Memo

Re: Consultation on an Application

Planning Application Ref: PL/26/0203

Proposal: Part single storey and part two storey side and rear extension with pitched roof and flat roof

Table 1: Summary of impacts	
Tree removal	None
Facilitation pruning	None
Demolition within RPA	None
New surfacing within RPA	None
New structures within RPA	None

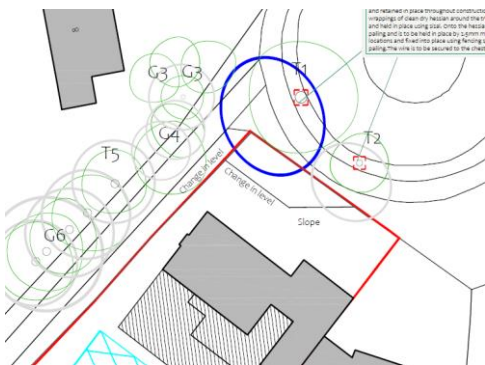
Section 6.0 Arboricultural impact assessment, Table 1, shows the tree impacts in relation to the proposal. This certainly is positive considering no tree removals, no facilitation

pruning, and there is no demolition/construction in RPAs.

However, I note the application form states *‘Low-height brick wall and associated piers raised and reconfigured to accommodate widened driveway access and to include remote operated sliding gates creating secure off road parking. Include provision for a separate access gate, operated manually, with stepped approach to principal entrance door of host property’*. The widening of the driveway and associated works such as service runs for the sliding gates (assumed electric) has not been included in the AIA. With reference to the Block Plan As Existing and Proposed, December 2025, Drawing No. 2437-P104, I note that none of these features are shown on the Block Plan and aren’t covered with the AIA. With reference to the Tree Protection Plan, 6th March 2026, Ref: AATPP7KEL, I note the driveway and entrance are likely within RPAs of the street trees on the frontage (T1 & T2). The AIA needs to be amended to demonstrate these access/driveway alterations, along with any service runs/excavation associated with the new sliding gate as they are within RPAs.

It is unclear on any vegetation removal on the frontage as a result of the driveway works so clarity needs to be sought on this. The works to the brick wall and piers also aren’t completely clear (not shown in the AIA/TPP) so it is difficult to appreciate their
